TEMPSTAR[®]
Heating and Cooling Products

Aluminum Coils & Fan Coils:
Quality.
Performance.
Easier Installation.

Part No. 401-22-0150-00 Printed 4/14

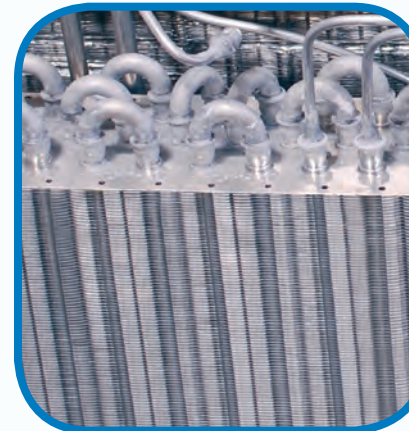
The new Tempstar fan coils are kicking copper to the curb to make way for a new aluminum round-tube, plate-fin evaporator coil...proving once again that change is a good thing, especially when it results in a design that offers quality, performance and installation ease.

Quality. The new aluminum round-tube, plate-fin design (not micro-channel) is more resistant to formicary corrosion, a major issue for every manufacturer in the HVAC industry.

Also, the new Tempstar aluminum evaporator coils include a copper transition joint that is made in the factory, so you will find the same copper connections on these new evaporator coils that you are used to seeing. You will braze copper-to-copper during installation. If you need to replace a coil, the process is easy, braze copper-to-copper as usual...making installation and service seamless and simple.
